**Ref No. PW-2018-02**  
**Armours Beach Site Improvements**  
**Design-Build**

**ADDENDUM #2**

**Ref No. PW-2018-02**  
**Armours Beach Site Improvements**  
**Design-Build**

**ADDENDUM #2**

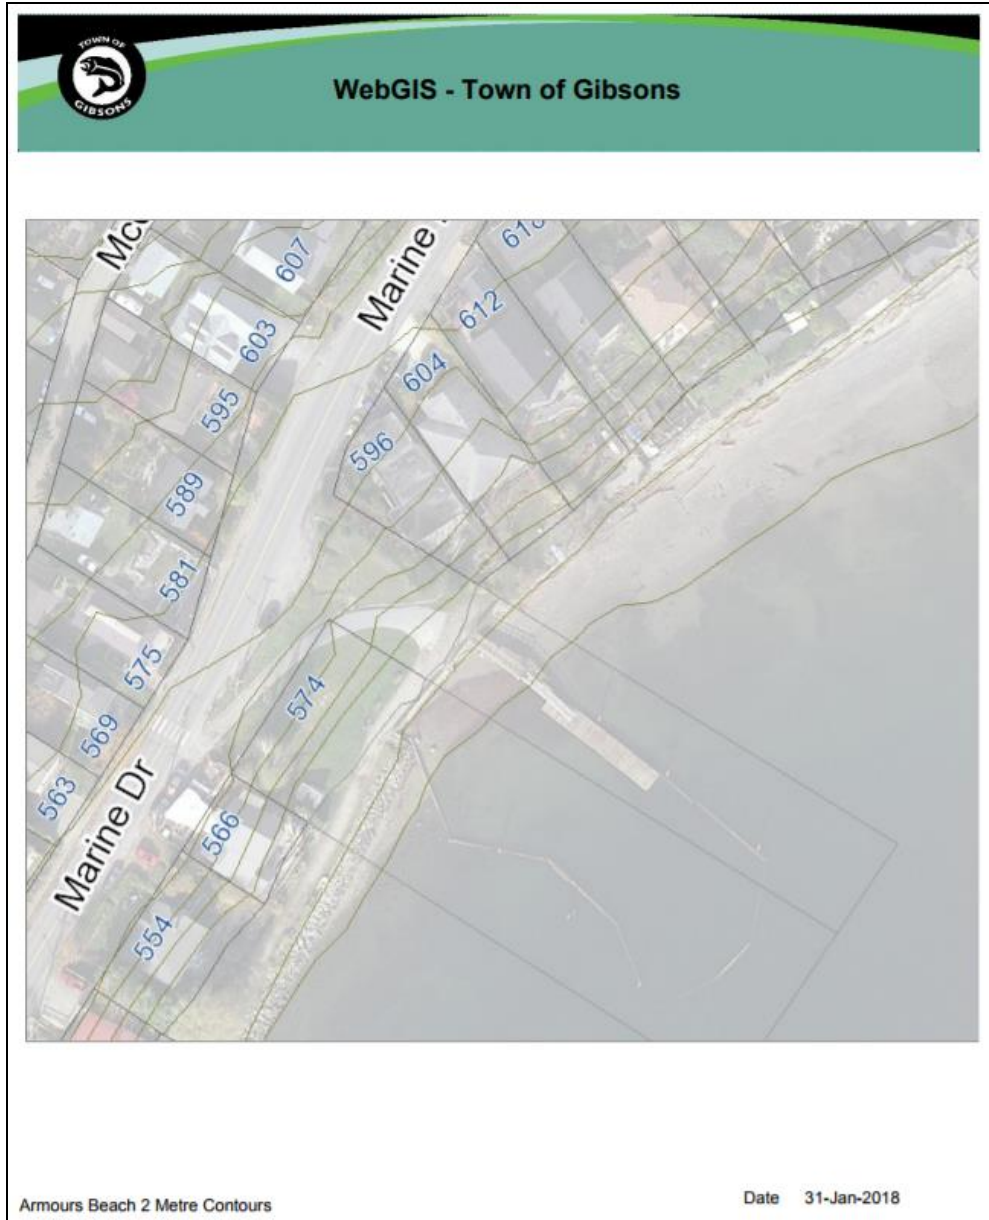
- 10. Q Is there a survey with some elevations/grades?  
A The Town has 2 metre contours available on our GIS which can be made available digitally if desired (see below).
